**TOWN OF BAY HARBOR ISLANDS
PLANNING AND ZONING BOARD**

May 3, 2016

Subject: Site Development Plan Application
Request for Modifications to 2/3/15 PZB Approved Plans
1150 100th Street Townhouses – 4 DU Residential Complex
1150 100th Street
Bay Harbor Islands Acct. No. BP2015-467
MMPA Acct. No. 01-0702-1002

RE: CASA VERDE at Bay Harbor Islands, a Condominium
1140 – 1150 93 STREET, Bay Harbor Islands
NARRATIVE OF P&Z SUBMITTAL REVISIONS

LEVEL 2 FLOOR PLAN - P&Z BOARD APPROVED - JAN. 20, 2015

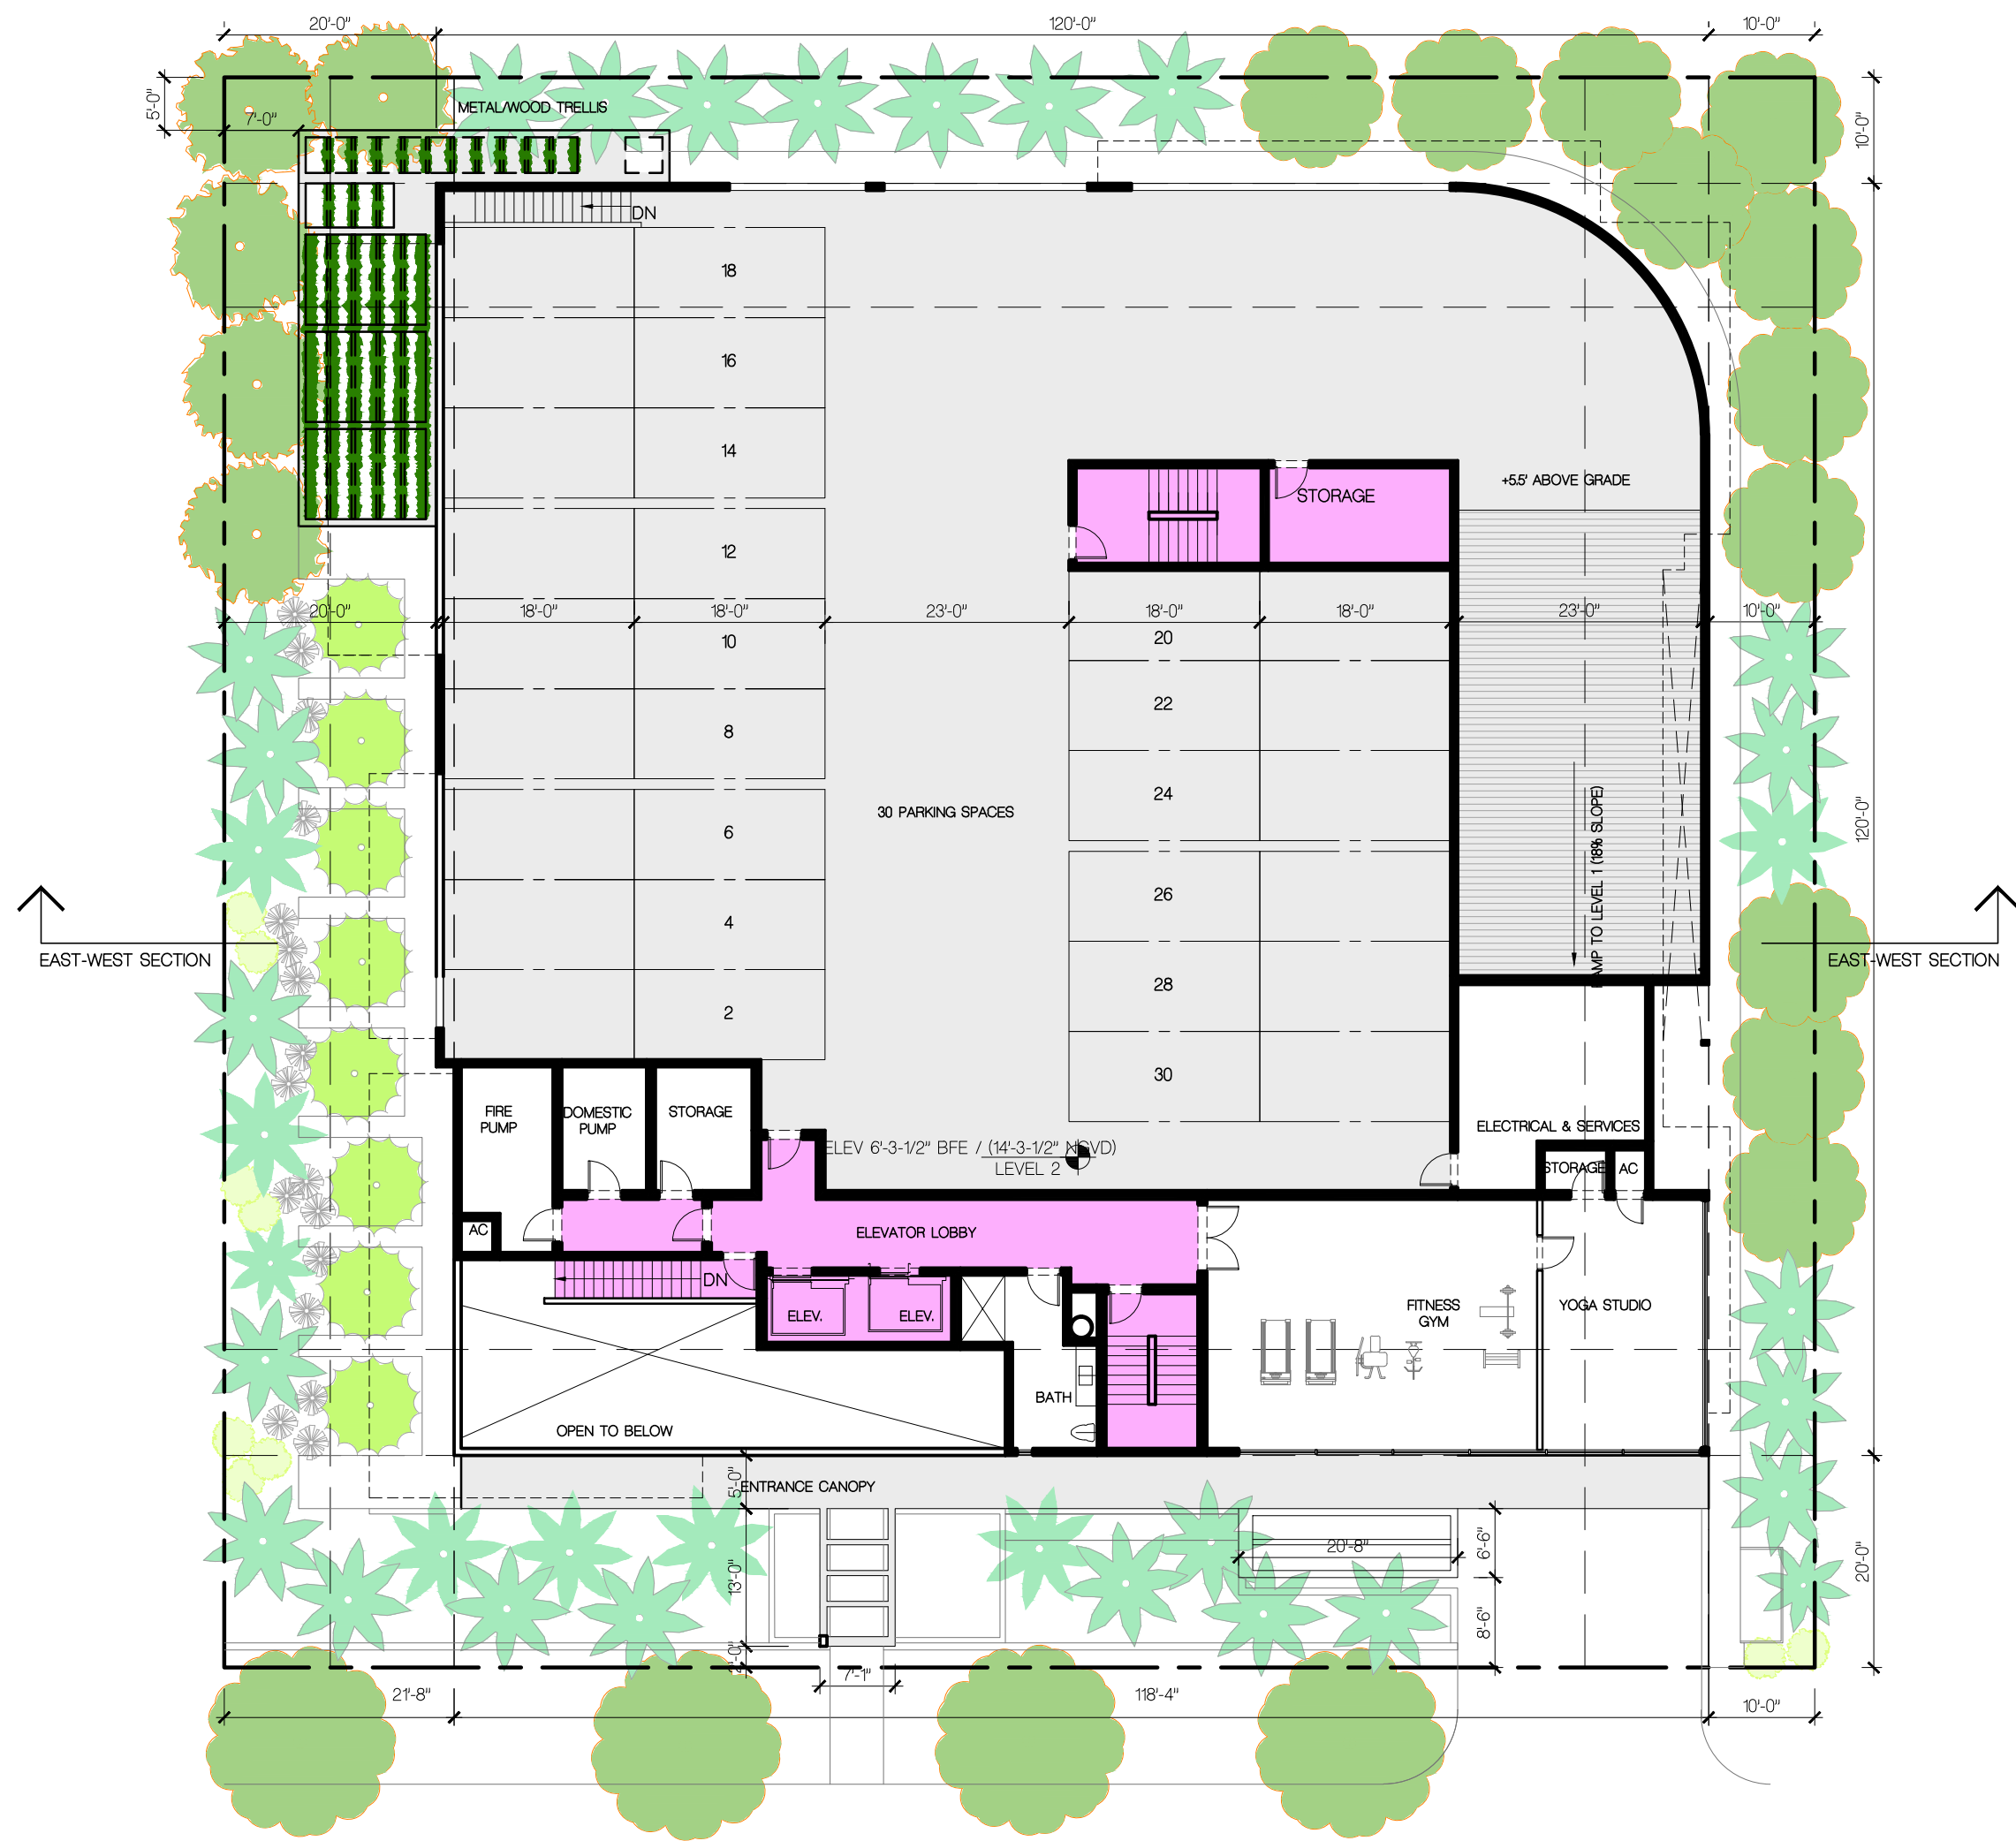
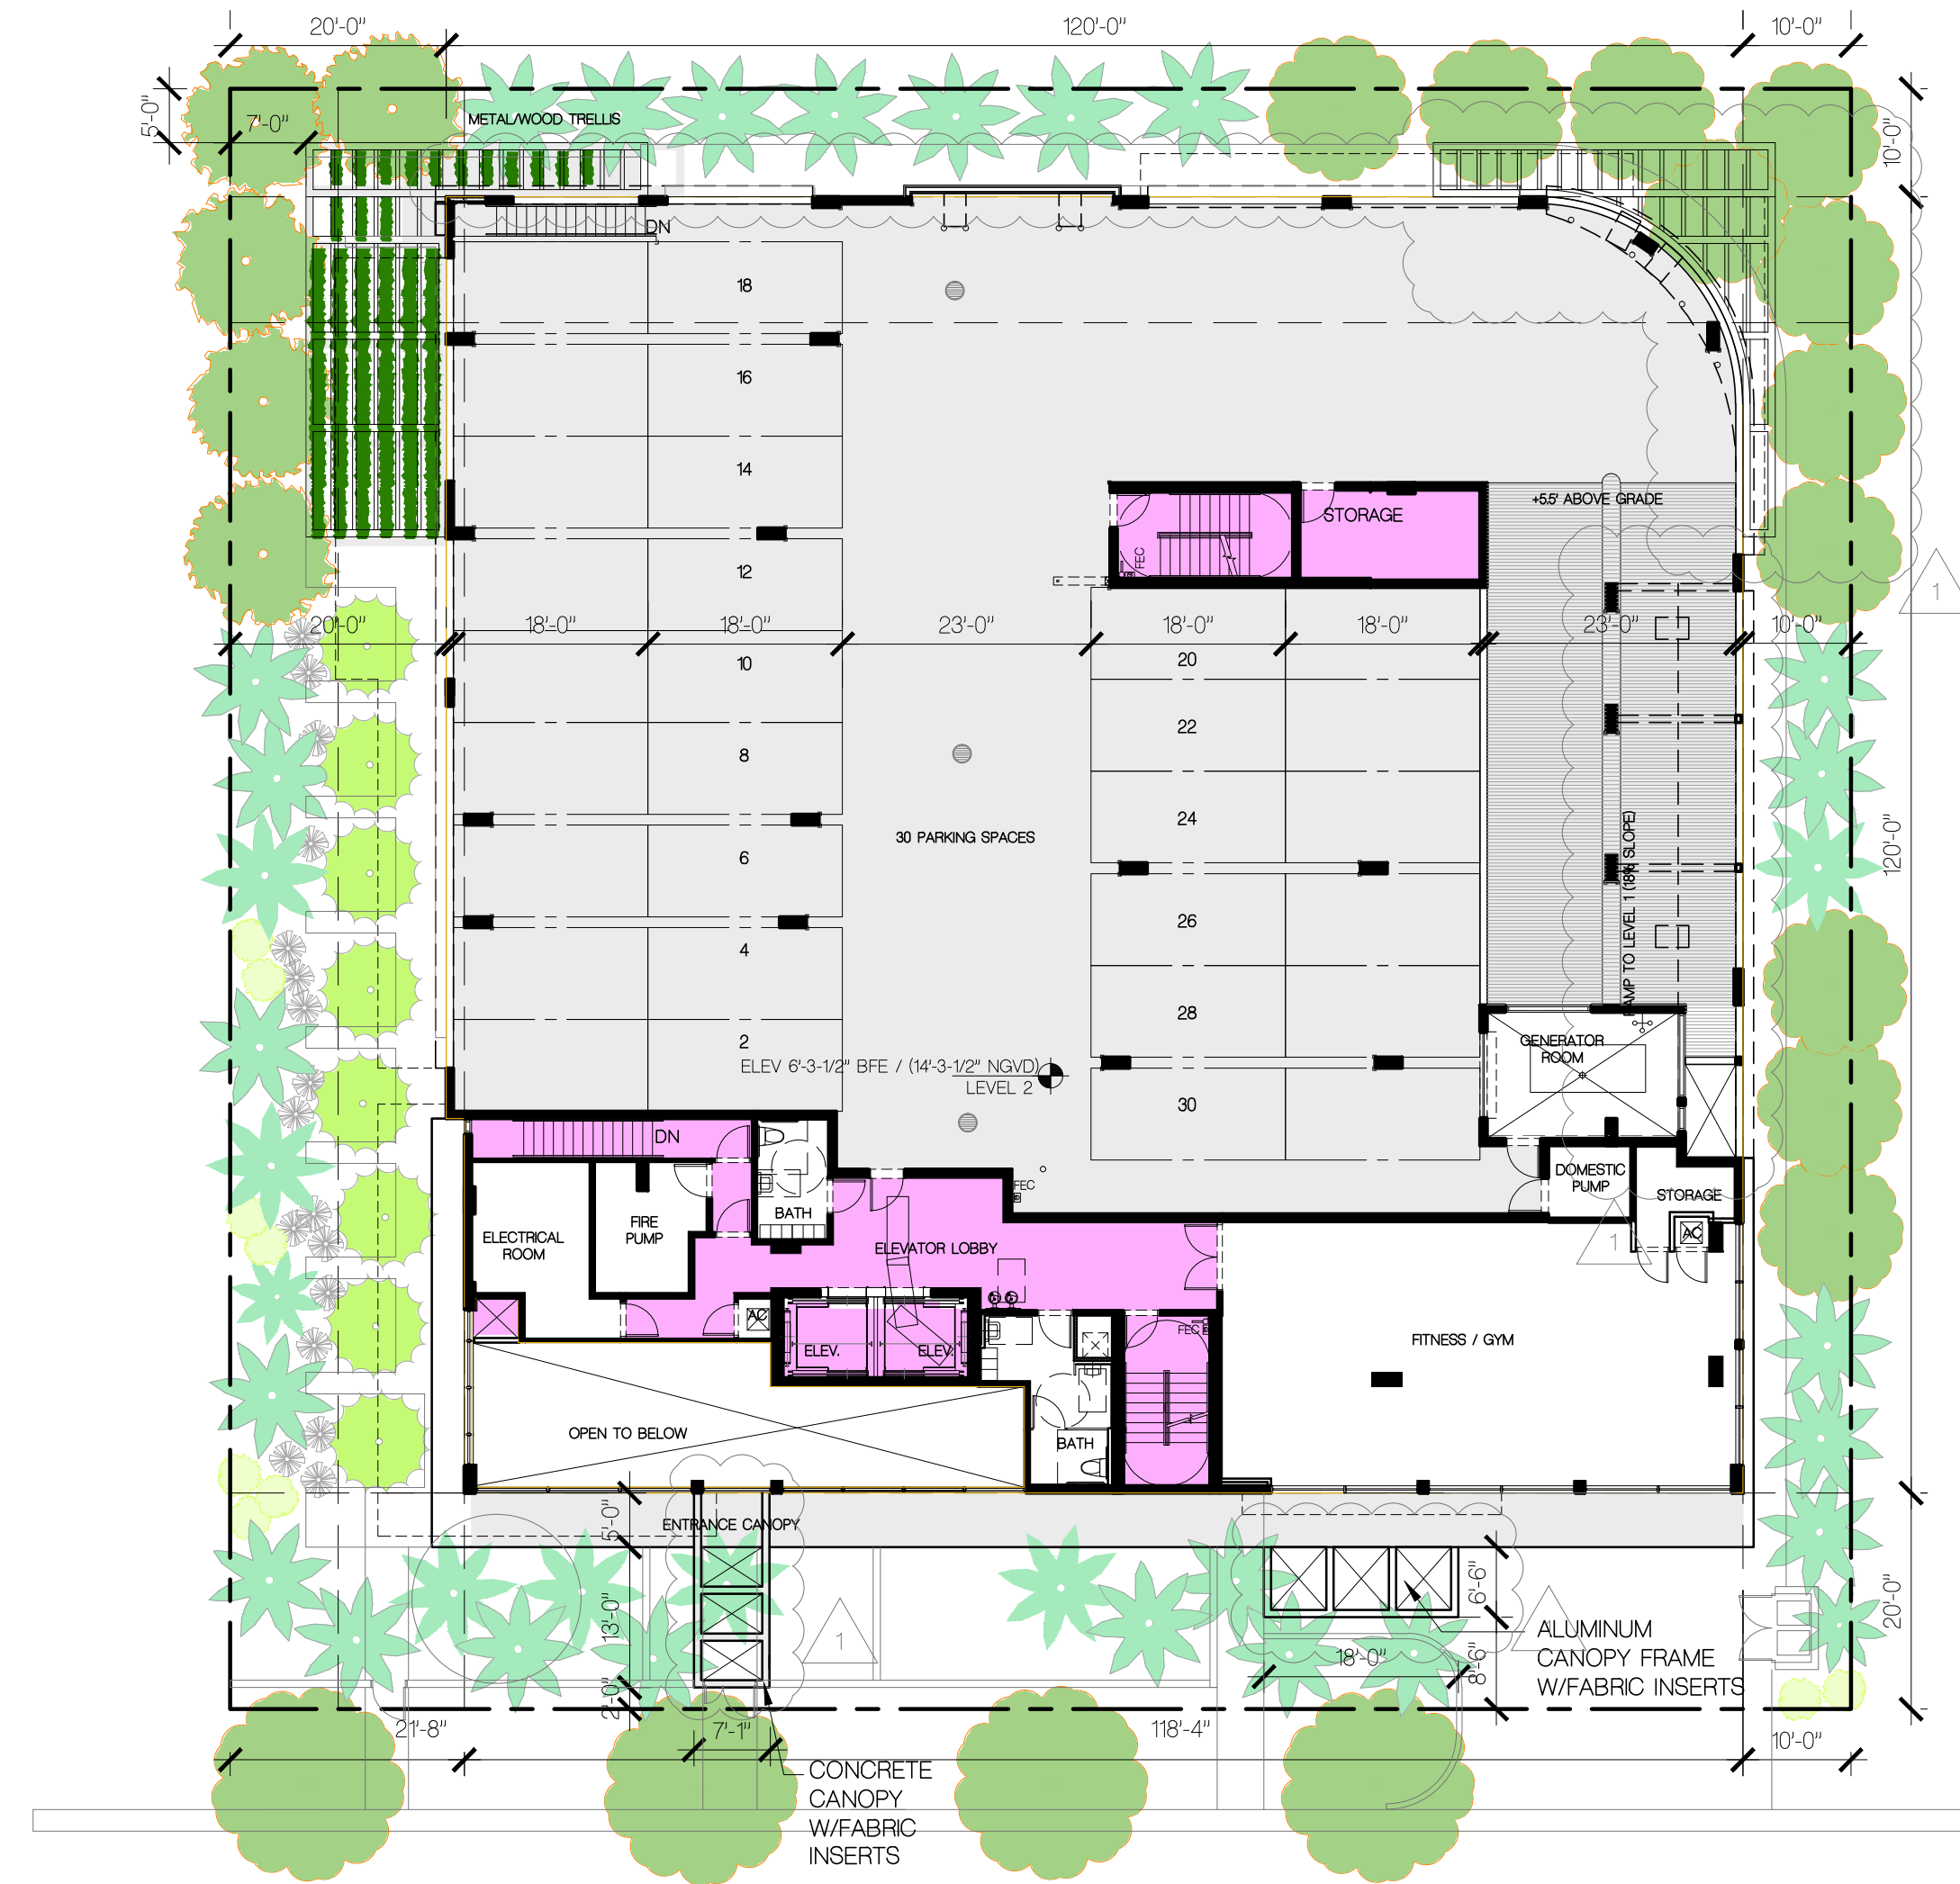
LEVEL 2:

- The entry canopy is slightly shifted towards East.
- The Trellis Entry canopy above guest parking is showing 3 divisions.
- Ramp & generator room West wall have been reconfigured and show the structure.
- Added trellis at the SW corner per condition of the P&Z Board approval of January 20, 2015.
- Added columns at the South façade.

NORTH ELEVATION - P&Z BOARD APPROVED - JAN. 20, 2015

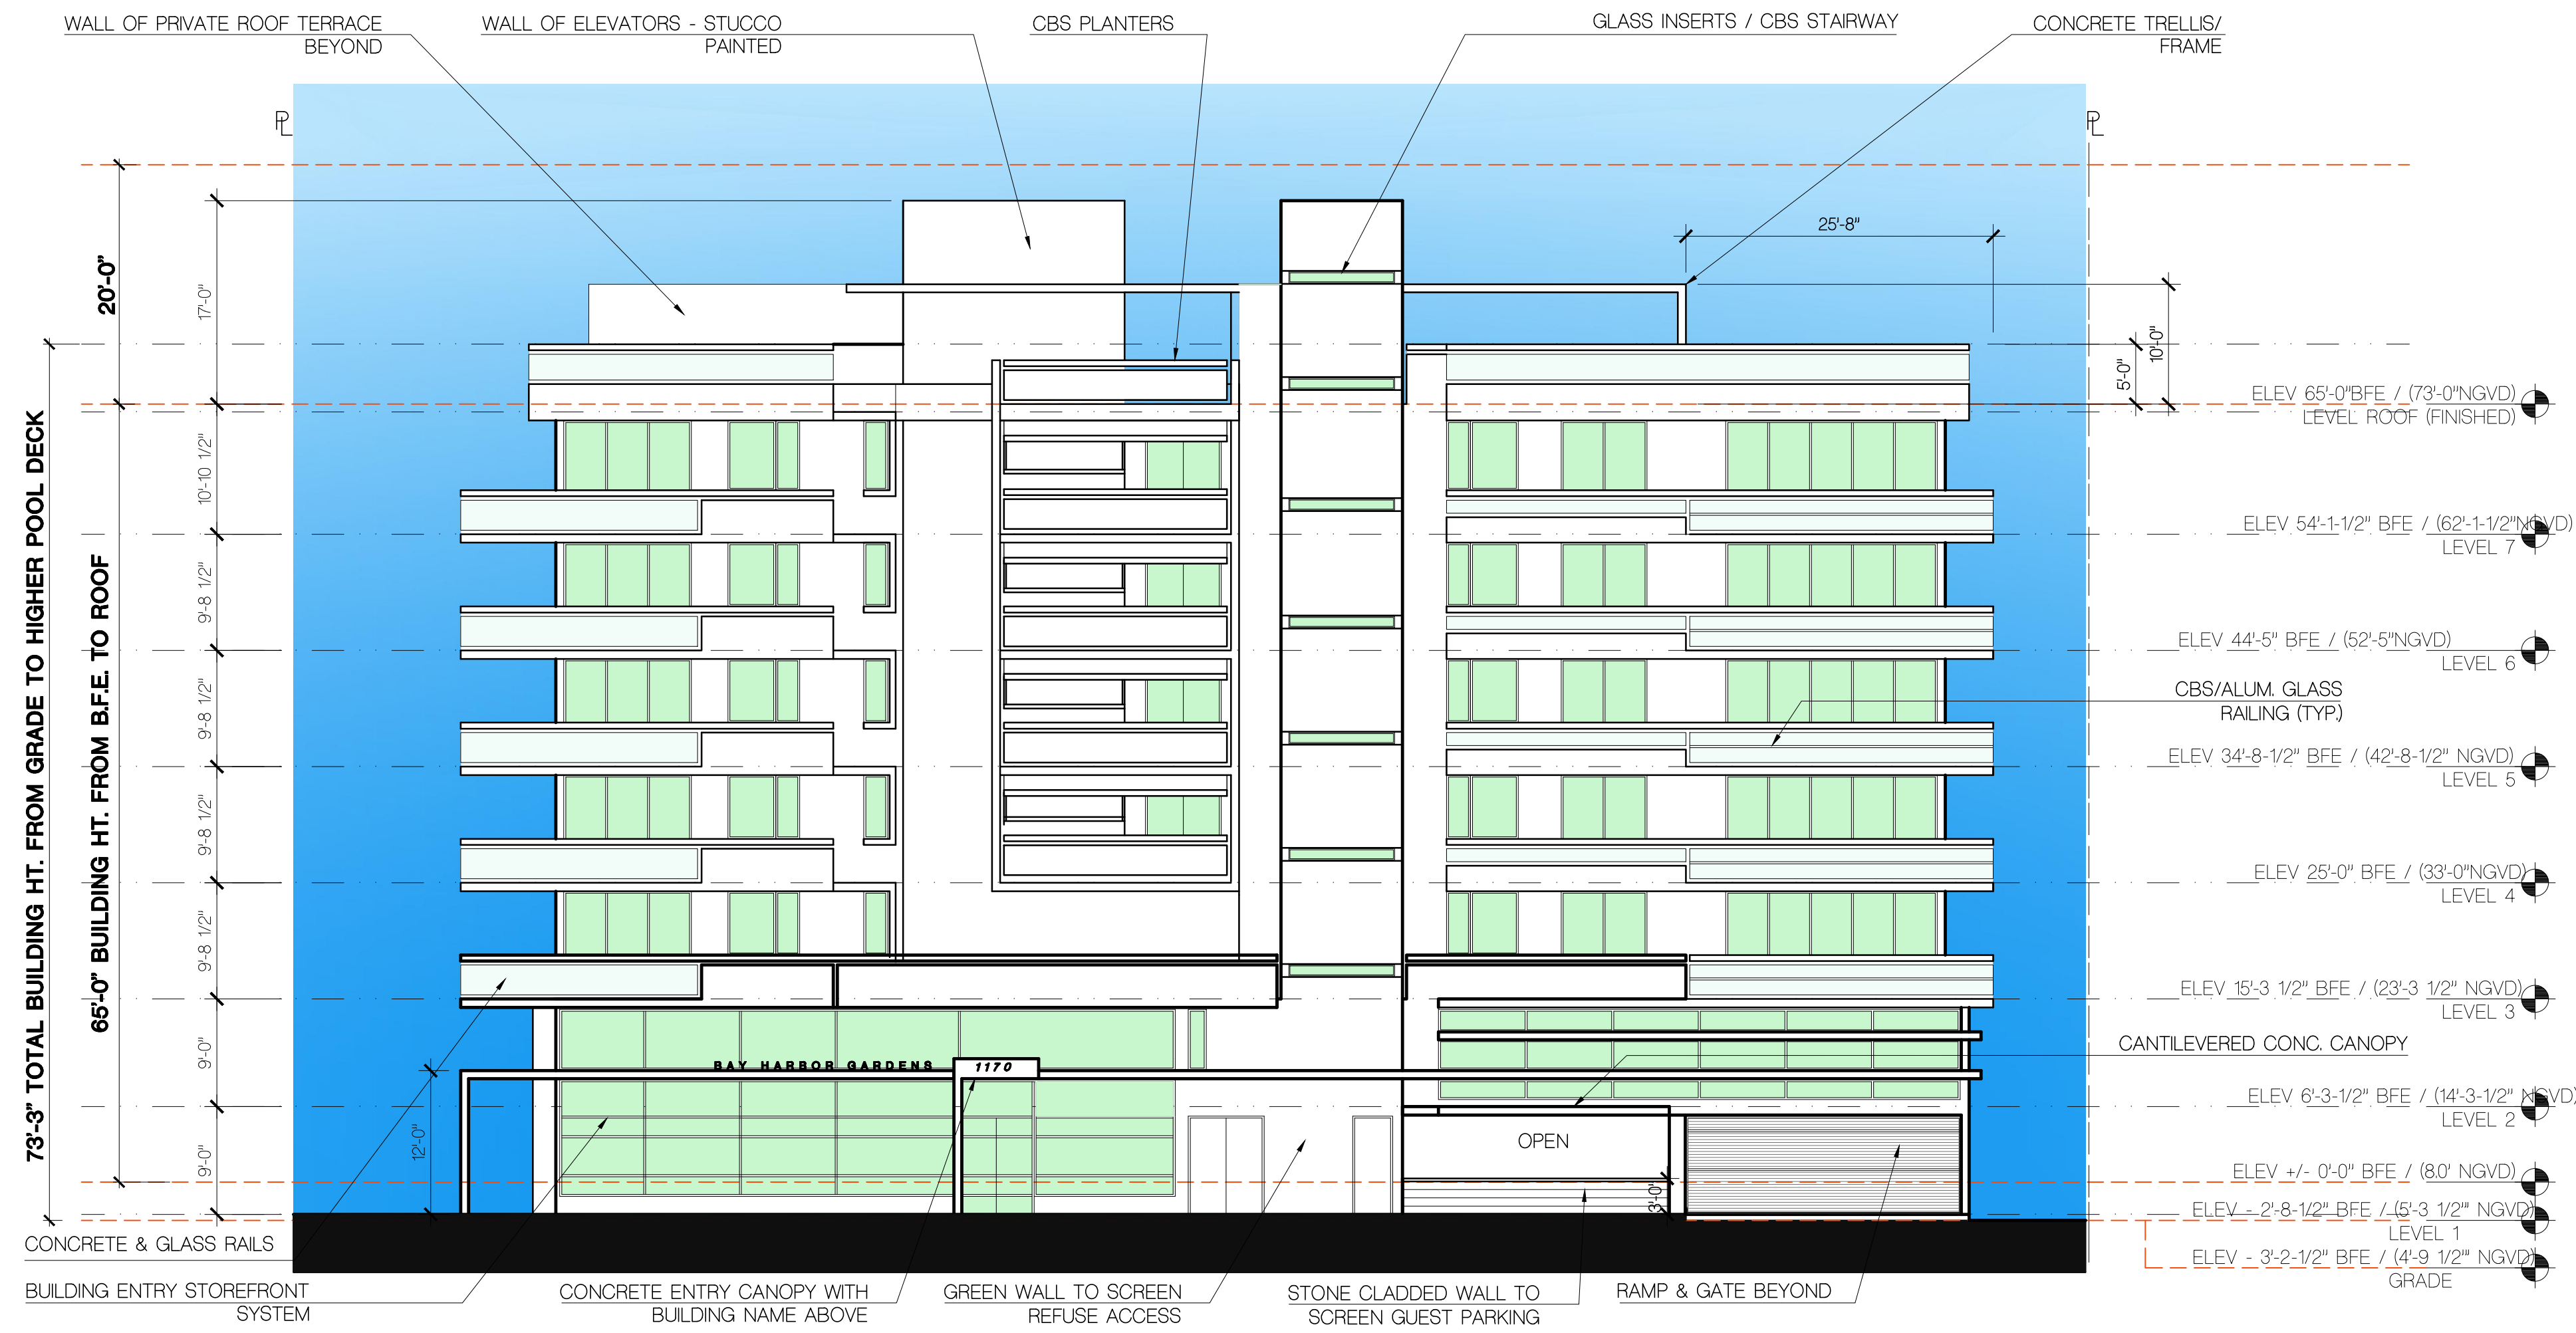
NORTH ELEVATION:

- The distance between the entry canopy column & the building it's been reduced.
- Number of building entry storefront panels is changed.
- The entry canopy is slightly shifted towards East.
- Refuse door it's been removed and stair door it's been recessed.
- Showing column by garage gate.
- Corrected graphics of NE balcony corners.
- Increasing the size of the corner columns next to glass doors.

- Uneven glass assemblies are changed to (2) panel glass assembly, in glass doors located above entry canopy & next to stair.
- Reduced width of the 5-panel glass assembly.
- Reduced height of the fabric mesh/metal panel shown in the center balconies.
- Added glass door at level 3, below typical center balconies.
- Added roof concrete trellis columns.
- Top of elevators & North stair parapets are brought to 20' above Roof deck.
